**Request for review of determination - Section 8.2(1)(a) of the Act
Development Application DA2018/1634
construction of a new dwelling house and swimming pool
16 Fairlight Crescent, Fairlight**

This request for review is to be read in conjunction with the accompanying plans DA00(6) to DA11(6) and DA13(6) to DA18(6) and DA 21(6) prepared by Vaughan Architects. These amended plans address reasons for refusal of the original application with such amendments able to be summarised as follows:

Figure 2 – Plan extract DA05(6) showing retained view corridors from the south and east facing living room windows and balconies of No. 14 Fairlight Crescent to the east of the subject site

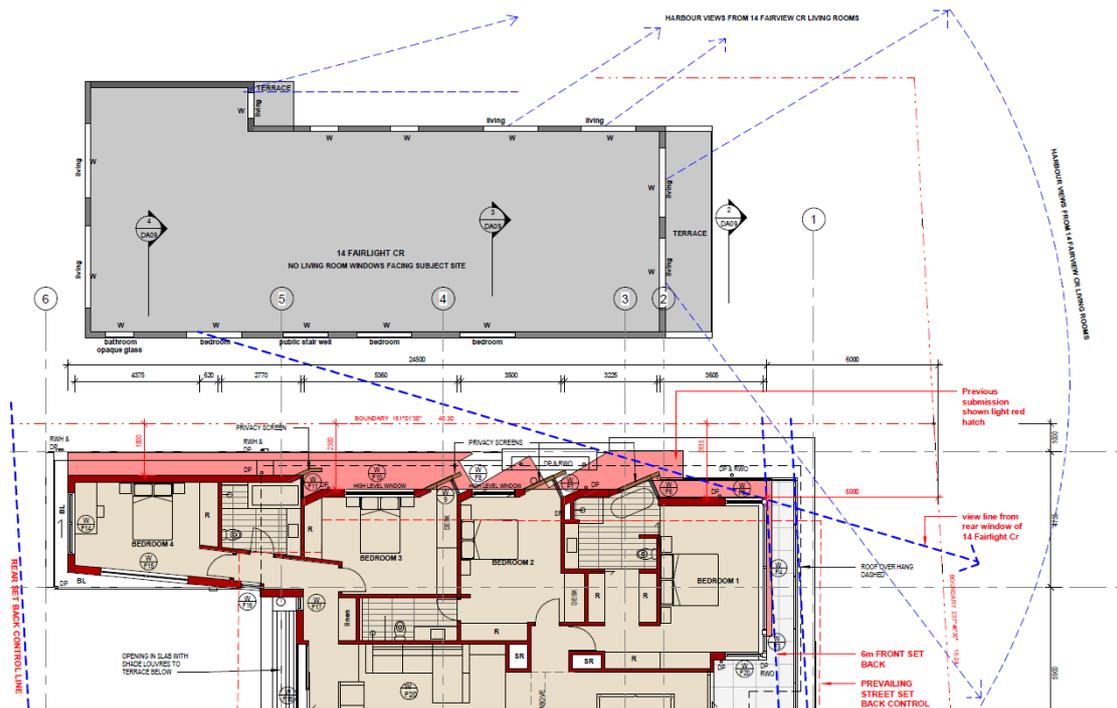
Response: Should Council consider the 6 metre default setback to be the applicable control, which we strongly dispute, the first floor south facing balcony does project within the setback by up to 1 metre at its eastern end and 300mm at its western end. This breaching element is unenclosed, sits behind the setback established by the existing dwelling house on the site and to that extent will not be perceived as inappropriate or jarring in a streetscape context.

- will not give rise to adverse privacy impacts to the south facing balconies at No. 14 Fairlight Crescent given the narrow width and limited utility of the balcony at its western end and will not give rise to any adverse privacy impacts on No. 18 Fairlight Crescent to the west of the site;
- will not give rise to any adverse shadowing impact on any adjoining property as depicted on the accompanying shadow diagrams; and
- will not give rise to any adverse view affectation given available view lines from both adjoining properties. The available harbour views from the south and east facing living room window and balconies at No. 14 Fairlight Crescent are depicted on plan DA05 and the accompanying marketing photographs at Figures 2, 3 and 4 below and over page. A view sharing outcome is maintained.

Comment: The breaching section of eastern wall will not give rise to any adverse view affectation given available view lines from both adjoining properties. The available harbour views from the south and east facing living room window and balconies at No. 14 Fairlight Crescent are depicted on plan DA05 and the accompanying marketing photograph at Figures 2 and 3. A view sharing outcome is maintained. The proposal satisfies this objective.
